## HISTORIC AND DESIGN REVIEW COMMISSION

**HDRC CASE NO:** 2025-111  
**ADDRESS:** 319 MISSION ST  
**LEGAL DESCRIPTION:** NCB 943 BLK 1 LOT 22  
**ZONING:** RM-4  
**CITY COUNCIL DIST.:** 1  
**DISTRICT:** King William Historic District  
**APPLICANT:** Nathan Manfred/French and Michigan  
**OWNER:** Lindsay Beale/BEALE LINDSAY &  
**TYPE OF WORK:** 2-story rear accessory structure construction  
**APPLICATION RECEIVED:** April 17, 2025  
**60-DAY REVIEW:** June 16, 2025  
**CASE MANAGER:** Bryan Morales

### REQUEST:

The applicant is requesting a Certificate of Appropriateness for approval to construct an approximately 1,812 sf rear 2-story accessory structure with a garage.

1 CASITA - ROOF PLAN  
SCALE: 1/4" = 1'-0"

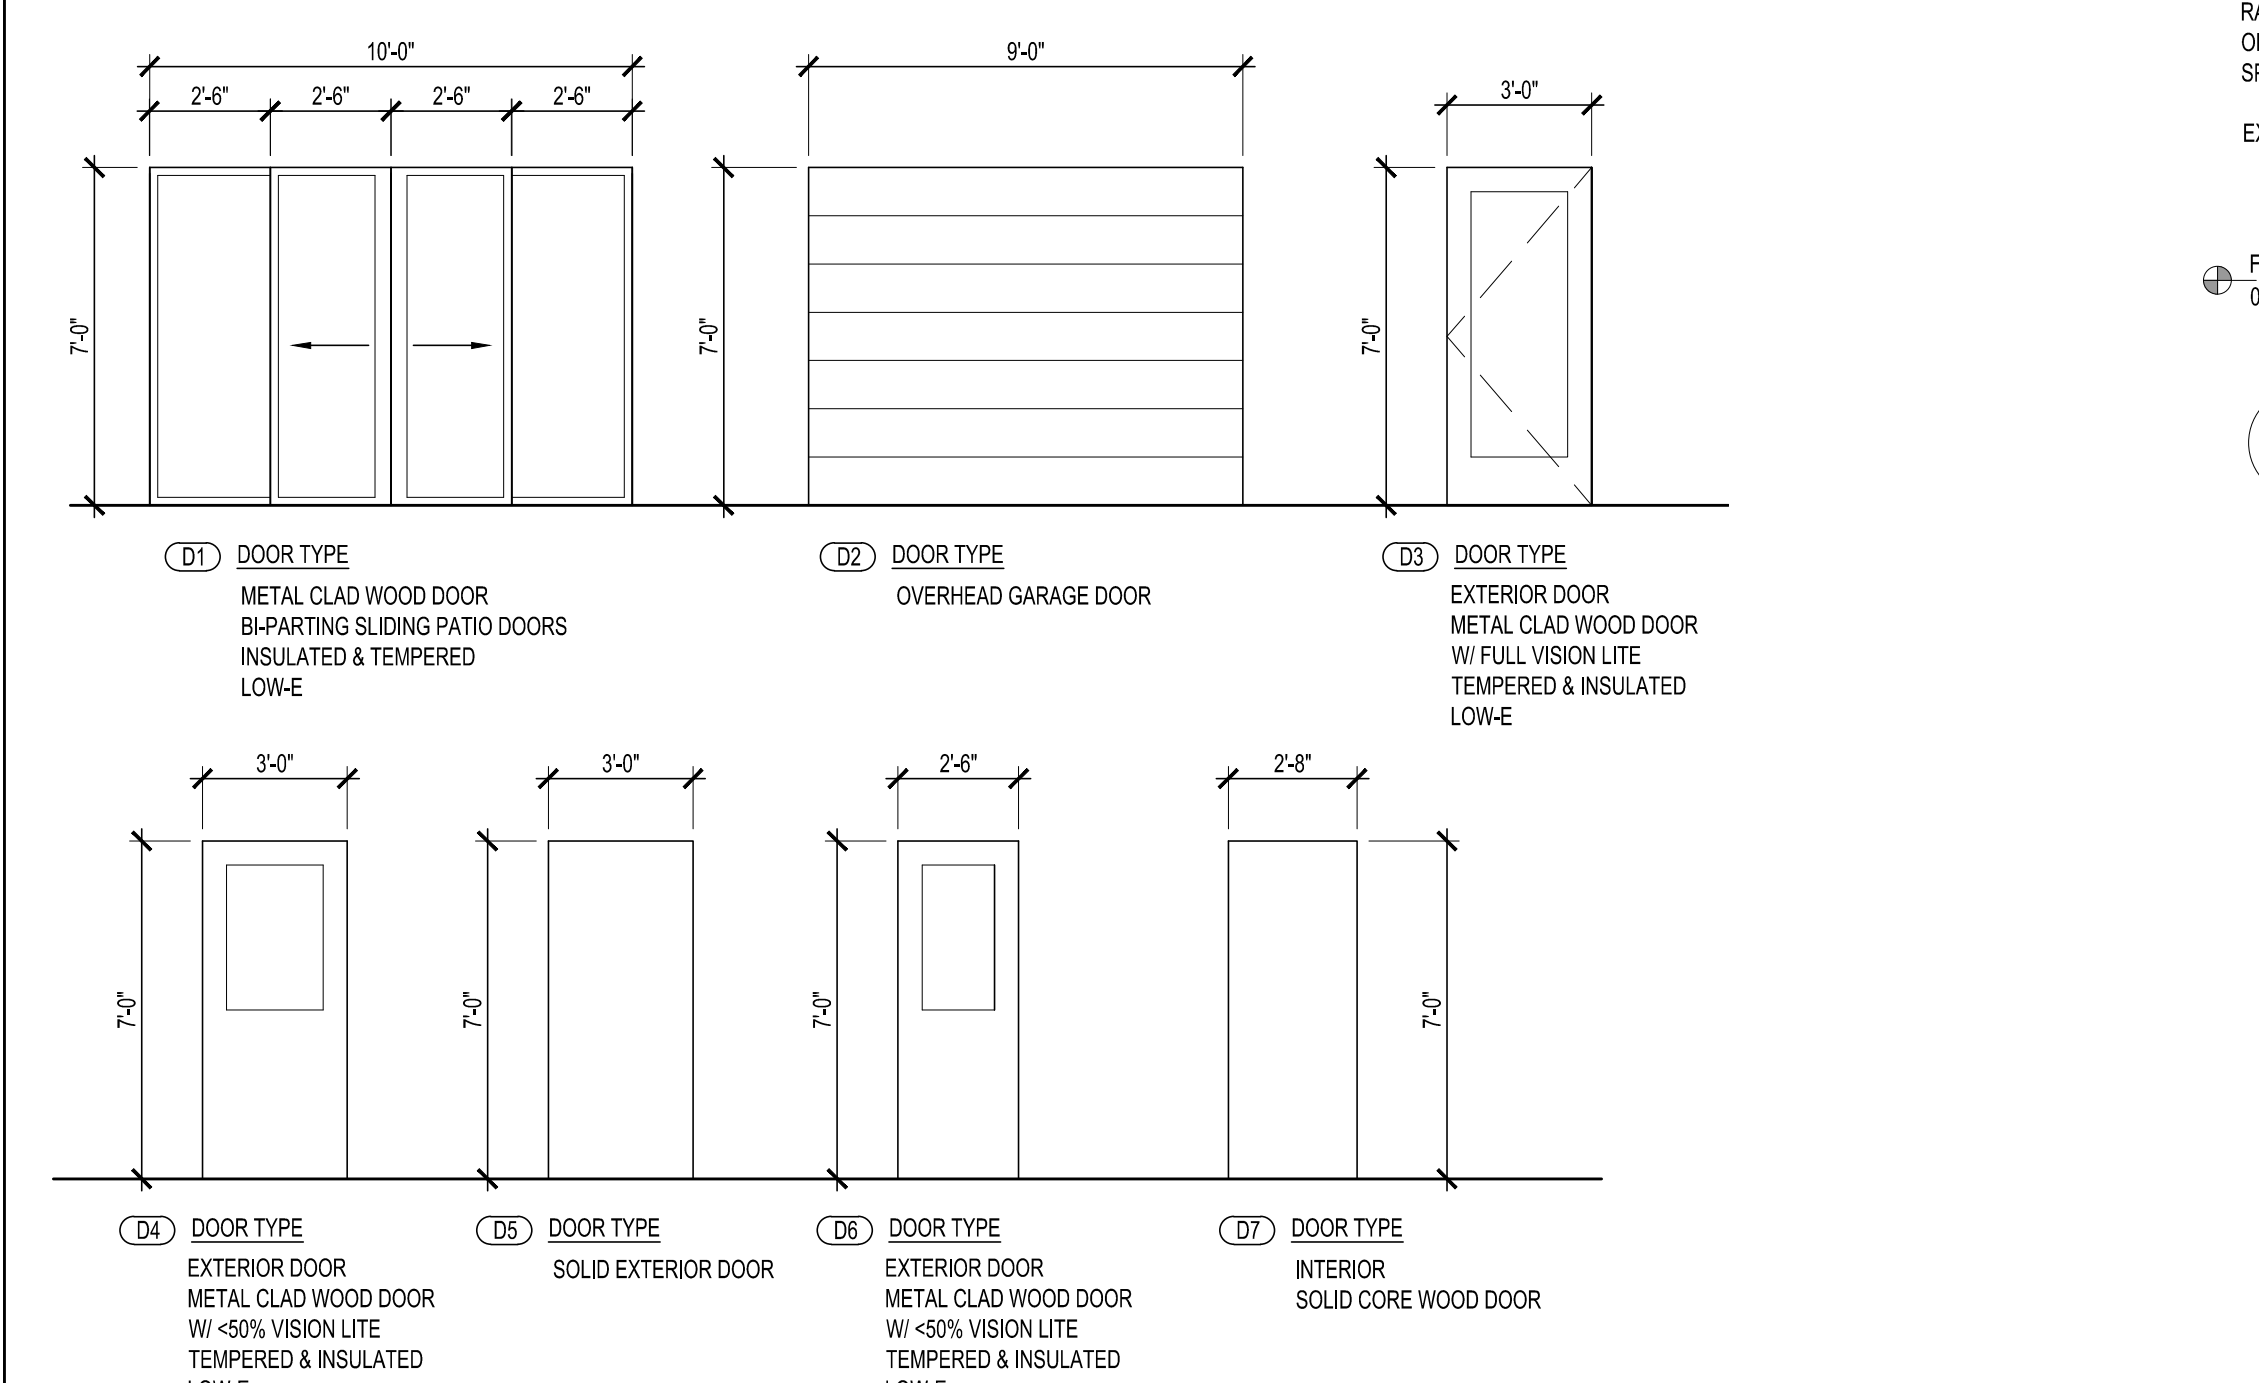
- f. **ROOF FORM & MATERIAL** – The applicant is requesting approval to construct a 2-story rear accessory structure with a garage featuring a front-facing standing seam metal gable roof over the 1-story massing and a front-facing standing seam metal gable roof over the 2-story massing. New Construction 5.A.iii. and 5.A.iv. note that new accessory structures should relate to the period of construction of the primary historic structure on the lot by using complementary materials and simplified architectural details. Staff finds the roof form and material conforms to Guidelines.

- ii. That the applicant install a standing seam metal roof featuring panels that are 18 to 21 inches wide, seams that are 1 to 2 inches high, a crimped ridge seam, and match the current finish or a standard galvalume finish. Panels should be smooth without striation or corrugation. Ridges are to feature a double-munch or crimped ridge configuration; no vented ridge caps or end caps are allowed. All chimney, flue, and related existing roof details must be preserved. An inspection must be scheduled with OHP staff prior to the start of work to verify that the roofing material matches the approved specifications. No modifications to the roof pitch or roof form are requested or approved at this time.

7 WINDOW TYPES  
SCALE: 1/4" = 1'-0"

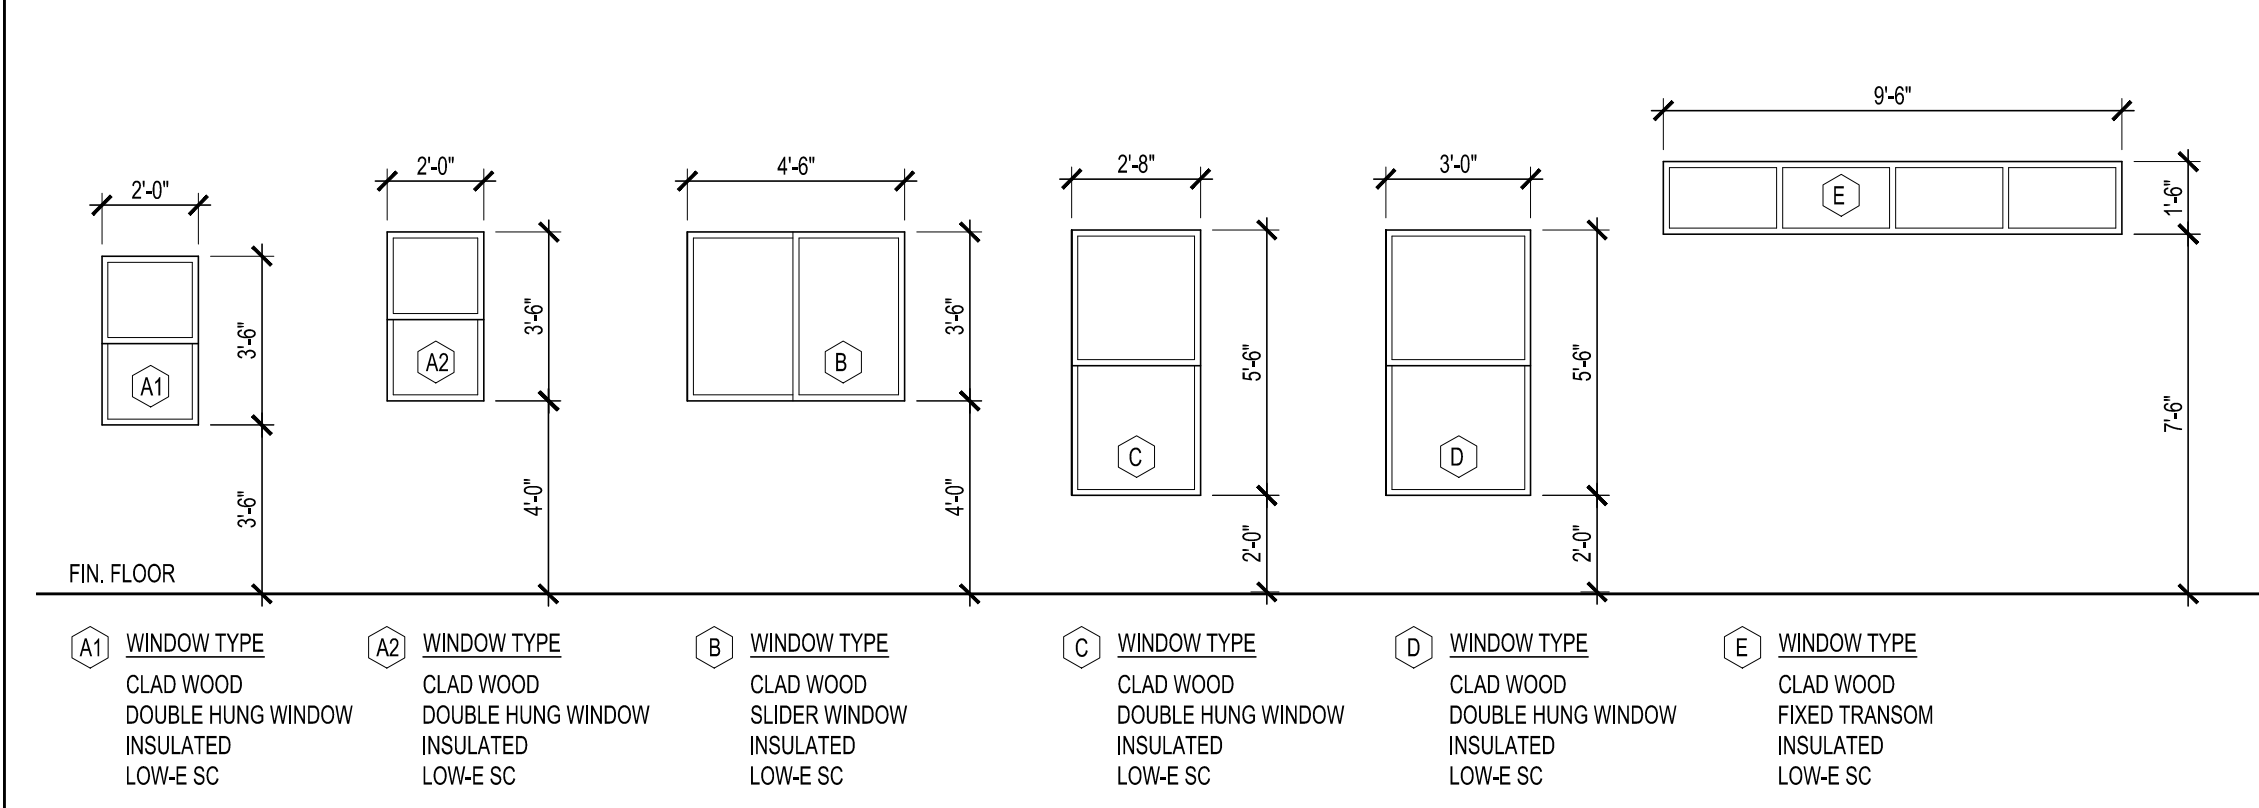
- j. **WINDOWS & DOORS (MATERIALS)** – The applicant has not provided staff window, door, or garage door specifications; however, the applicant has noted in the application the windows and doors will feature metal cladding. Per *Standard Specifications for Windows in New Construction*, new windows on new construction should relate to the windows of the primary historic structure in terms of materiality and overall appearance. Windows used in new construction should be similar in appearance to those commonly found within the district in terms of size, profile, and configuration. New Construction 5.A.v. states to incorporate garage doors with similar proportions and materials as those traditionally found in the district. Window, door, and garage door specifications are required for review prior to the issuance of a Certificate of Appropriateness.

- i. That the applicant installs a fully wood or aluminum-clad wood window that meet staff’s standard window stipulations and submits updated specifications to staff for review and approval. The windows should feature an inset of two (2) inches within facades and should feature profiles that are found historically within the immediate vicinity. Meeting rails must be no taller than 1.25” and stiles no wider than 2.25”. White manufacturer’s color is not allowed, and color selection must be presented to staff. There should be a minimum of two inches in depth between the front face of the window trim and the front face of the top window sash. This must be accomplished by recessing the window sufficiently within the opening or with the installation of additional window trim to add thickness. Window trim must feature traditional dimensions and architecturally appropriate sill detail. Window track components must be painted to match the window trim or concealed by a wood window screen set within the opening.
